TECHNICAL MEMORANDUM

PRODUCT :CSL

No : 0097

SUBJECT: Rattling Hot Gas Solenoid on CSL Cabinets (XWG Valve).

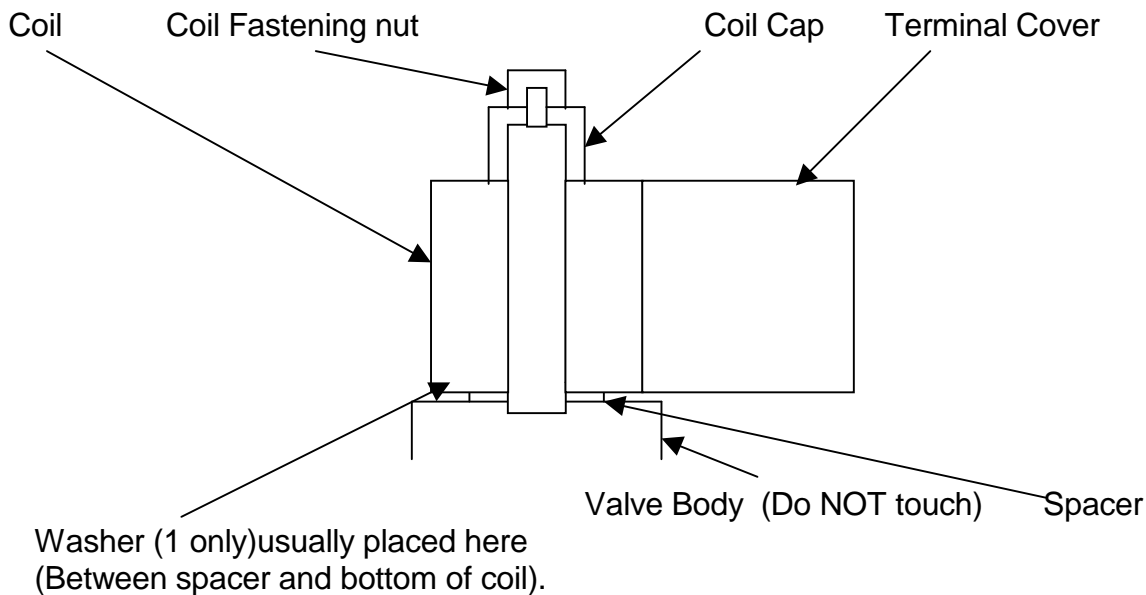
The Rapid-Action Hot Gas solenoid fitted to the CSL range of cabinets can sometimes develop an intermittent rattle.

A cure can usually be effected by installing a flat washer under the coil on the solenoid valve. Turn the power OFF. The Hot-Gas solenoid is mounted on the external rear wall of the cabinet. (looking from the rear of the cabinet). Undo the Coil fastening nut and carefully lift the cap and Coil free of the valve stem. Slip the washer down over the valve stem so that it rests on top of the spacer. Refit the Coil, Cap and Nut (tighten firmly). Retest.

The Contherm Part No for the washer is: **WASHER 29** This is a ½" 1mm thick steel washer.
